Meeting Notes

PROJECT: Southdale Library Site - Public Work Shop #4
Commission Number 3857-002-00

Purpose: Public Open House

The following images document the notes and markups by each group to the two site concepts during the small group discussion (not in any particular order):

CONCEPT #1

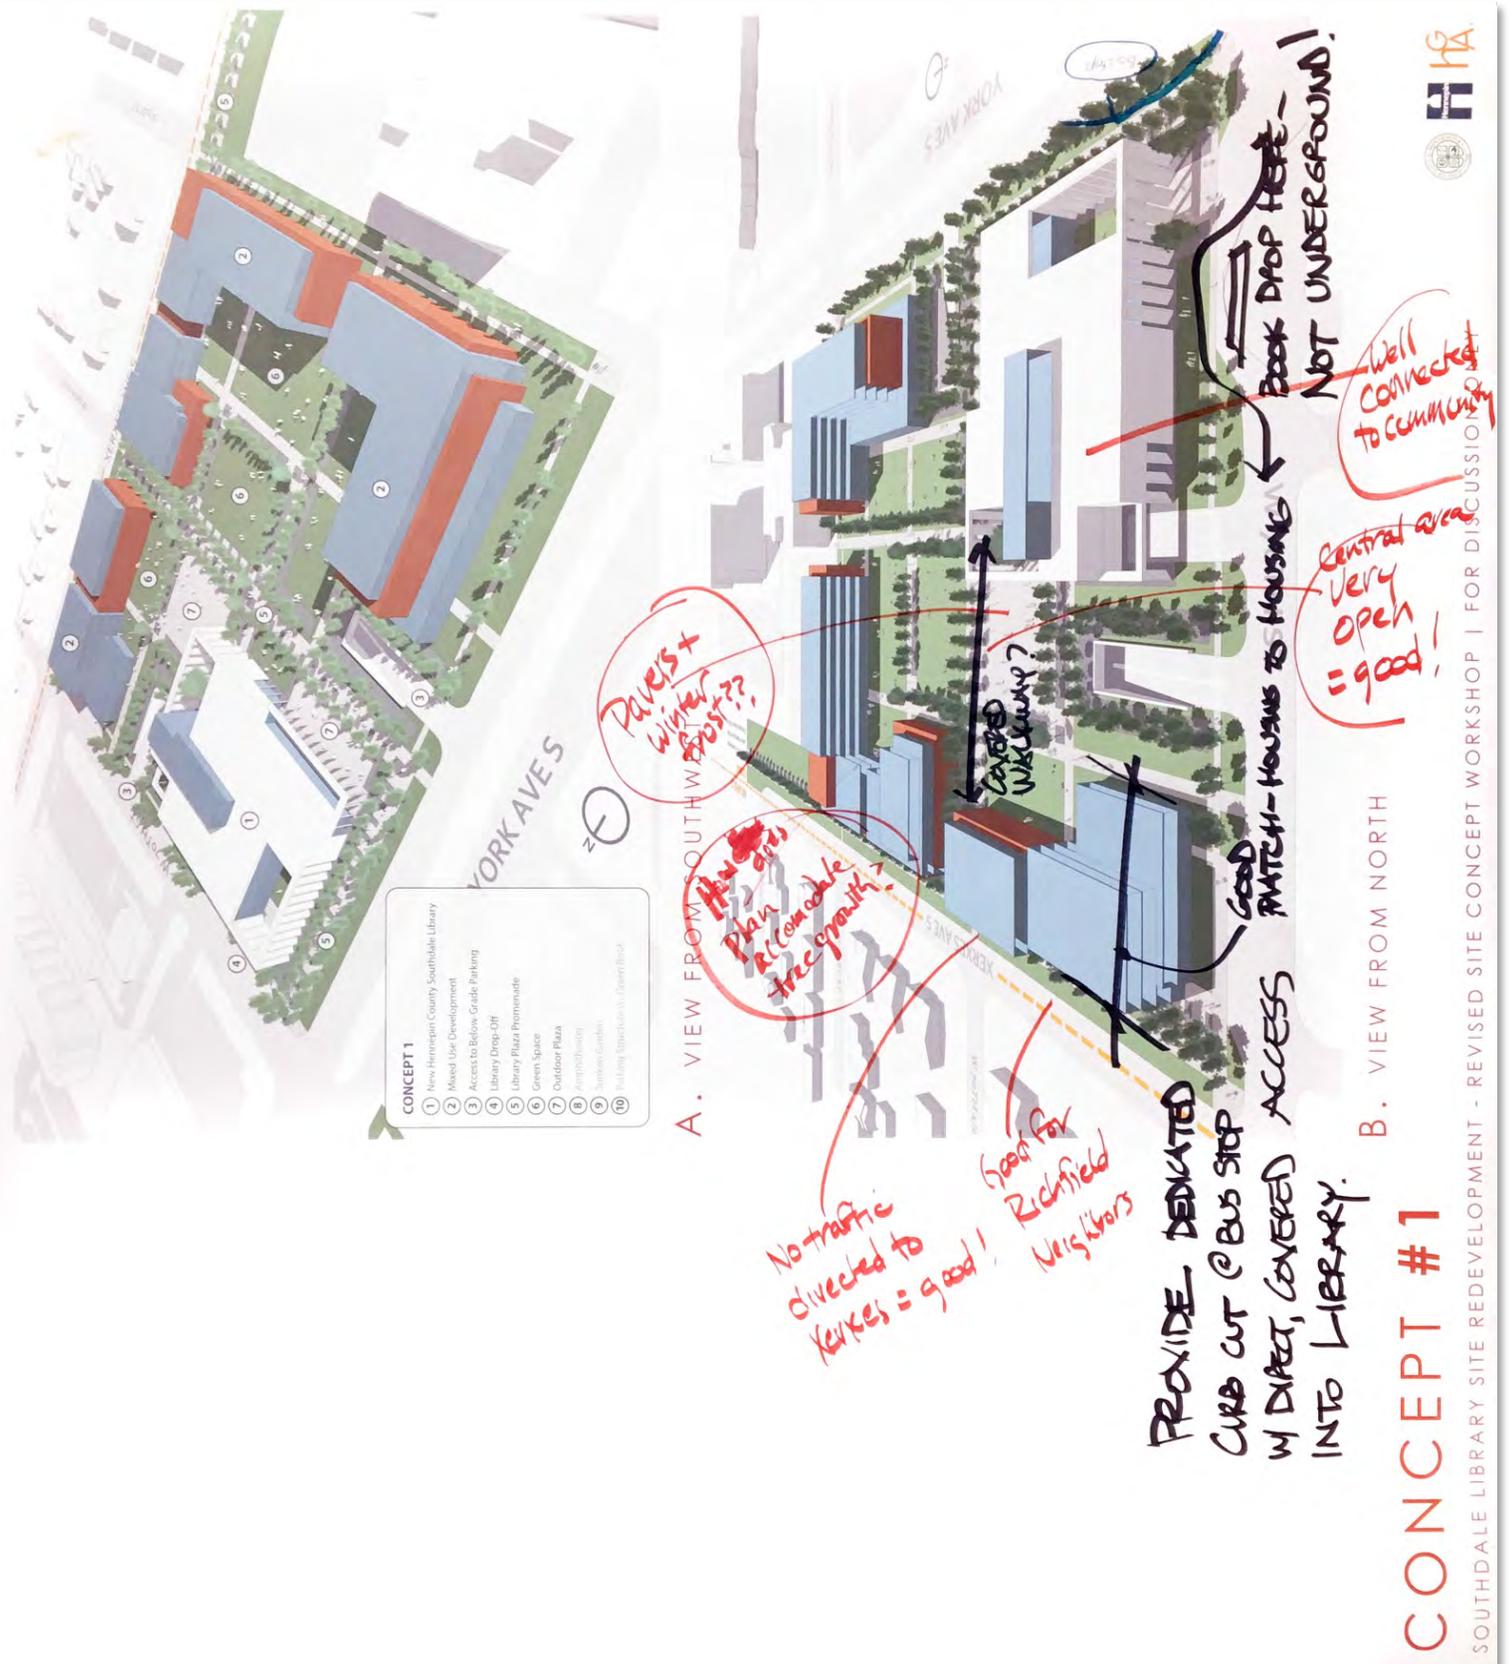
*Don't like library
 on York + 70th
 Bikes & kids walking
 are close to very busy
 intersection for
 walking (both concepts)*

Pavers + winter sport??

How do you plan to make tree growth?

No traffic directed to Keyes = good!

Good for Richfield neighbors

PROVIDE DEDICATED CURB CUT @ BUS STOP W/ DIRECT, COVERED ACCESS INTO LIBRARY.

GOOD MATCH - HOUSING TO HOUSING

Central area very open = good!

Well connected to community

BOOK DROP HERE - NOT UNDERGROUND!

covered walkway?

CONCEPT #2

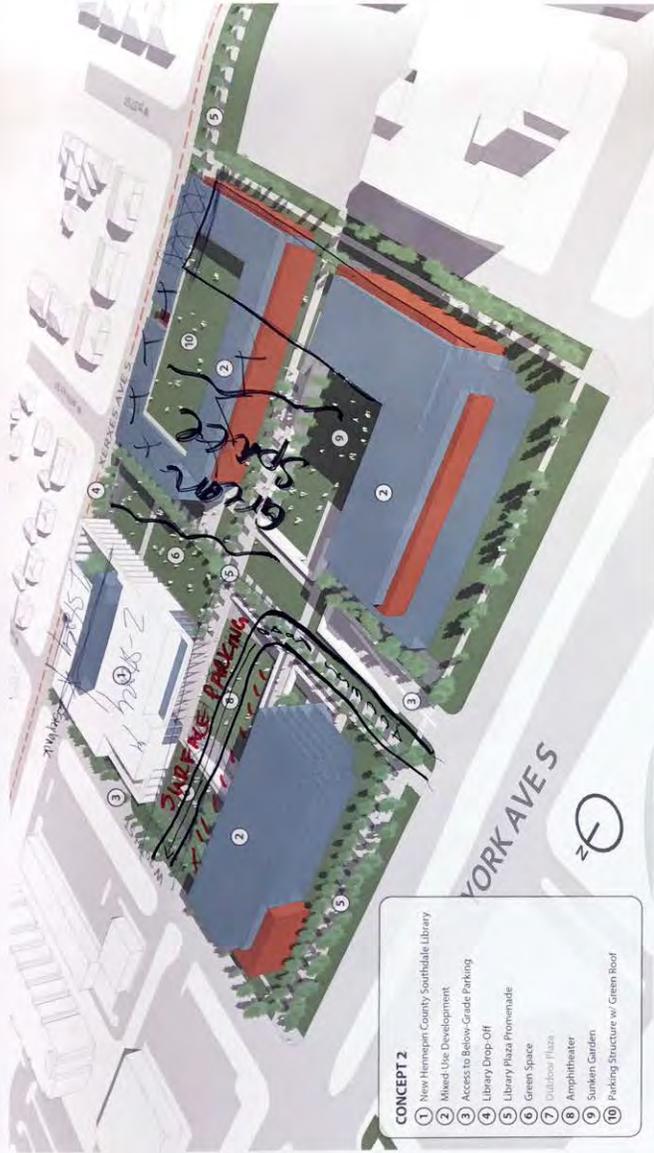
* Library on taxes
 quiet, more residential friendly

* leaves option for taller bldgs. on park if finances require more density

* underground parking
 Car patrons don't see the beauty of the bldg. (can be solved by)

* more friendly, safer for kids + bikers from Richfield Residences

* small req for retail
~~Somebody's~~ big box
 Xeroxes - have enough north of ~~70th~~

CONCEPT #2

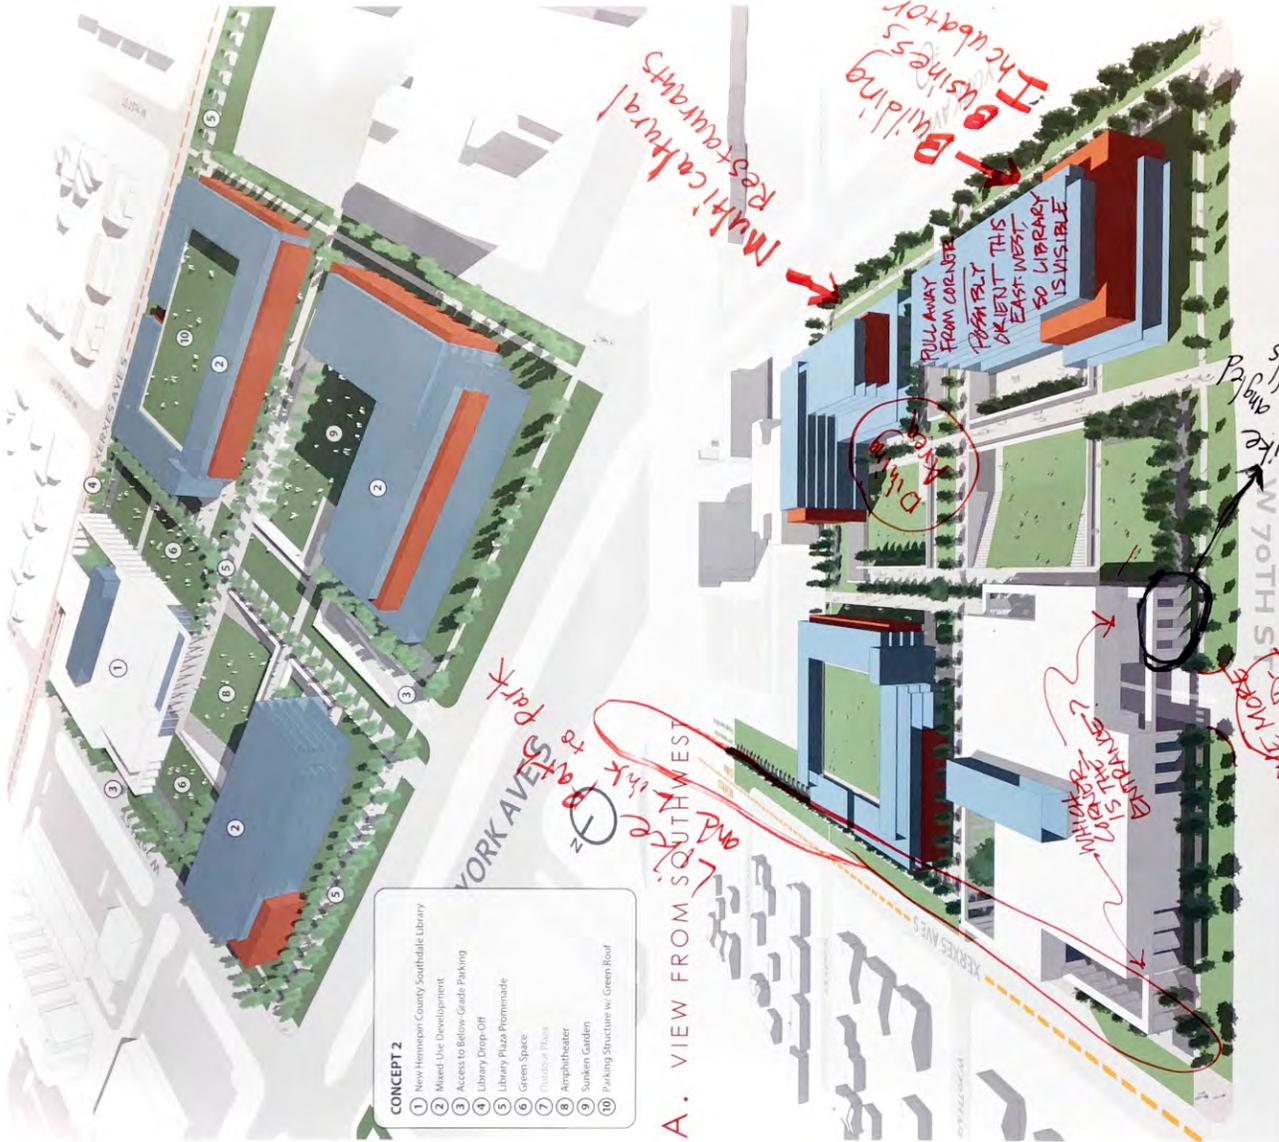
"The PRIMARY REASON for this spot is the LIBRARY"

CONCEPT #2

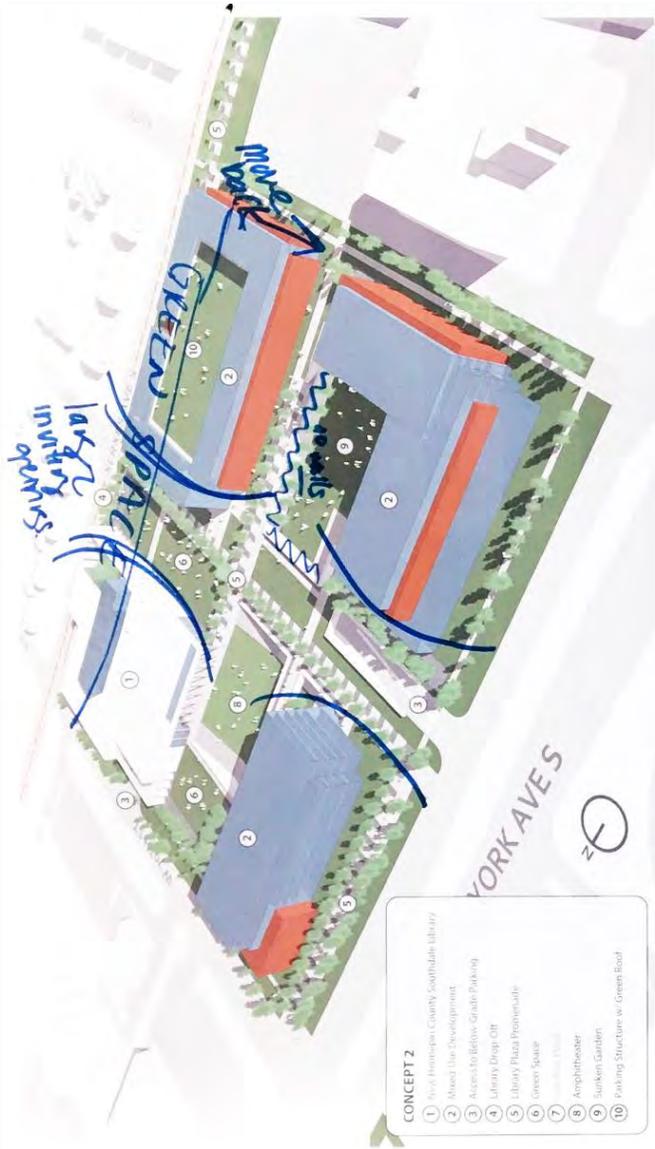
RAIN WATER CAPTURE TO IRRIGATE LANDSCAPE (CONCRETE + Z)

LIBRARY LESS ACCESSIBLE TO BUS RAILS

- Less open fields in central area

- Grass = good!
 - Slope = good!
 pipe axis

* Flat front park in Vermont - opens in nature
 posted by elements that are mentioned in CONCEPT #2 in terms of park in path (less travel) (eg. park in path less travel)

CONCEPT #2

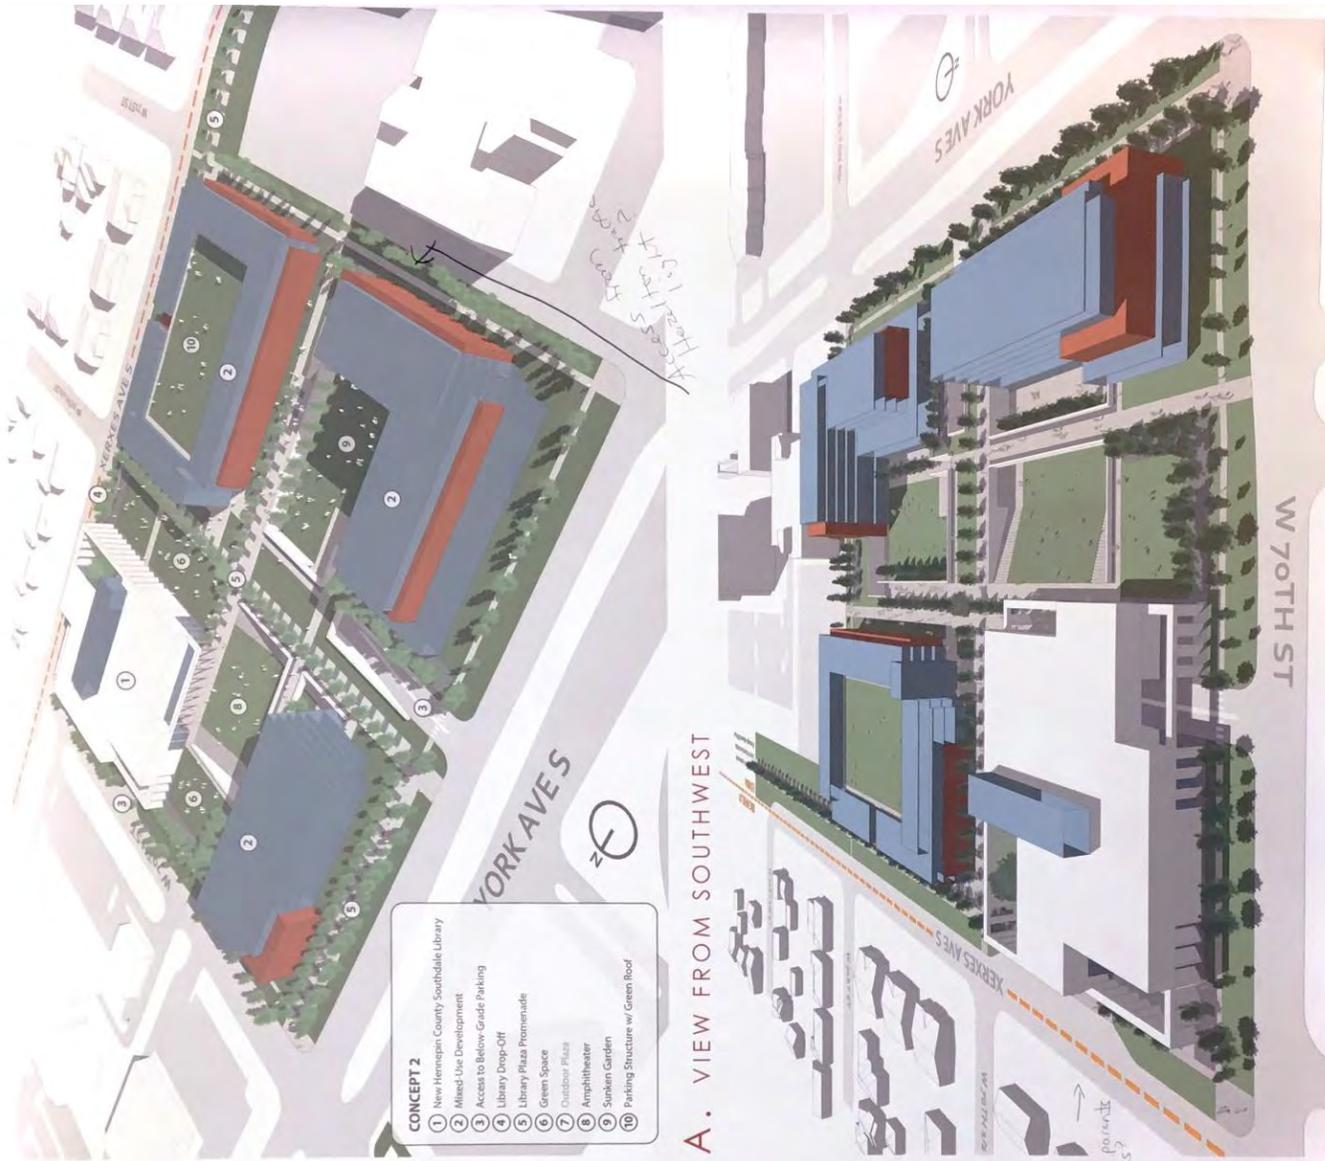
- if you want a park about the field primary center - signal both sides
- OUTDOOR AMPHITHEATER IS A GOOD IDEA WOULD THE LIBRARY BE BUILT IN THE USE BEING MADE MORE PERENNIAL SPACE?

- USES BUILT THERE ARE A COMPANION SPACE SIMILAR TO CARO MUSEUM SMALL PERENNIAL.
- like the library on 10th & York
- needs more green space that special call series the library

- more like art center to this location
- if you want a park about the field primary center - signal both sides
- MOVE GREEN SPACE OUTWARD - SO IT'S NOT SO CLOSE TO COMMUNITY

- INCLUDE AFFORDABLE HOUSING
- UNDERGROUND PARKING IS A GOOD SOLUTION. PLS AVOID ABOVE GROUND ENTRIES
- 1. PREFER THE USES ON YORK + 14TH (CONCEPT 1)
- MAKE SPACES

- TOO MUCH FLATLY - Maybe Green Space right thru the middle - TO much signage on top - anything
- Library needs to be special what it is - A nice public use of space

- INDEPENDENT RETAILER (BOOKS, COMICS)
- like the underground parking
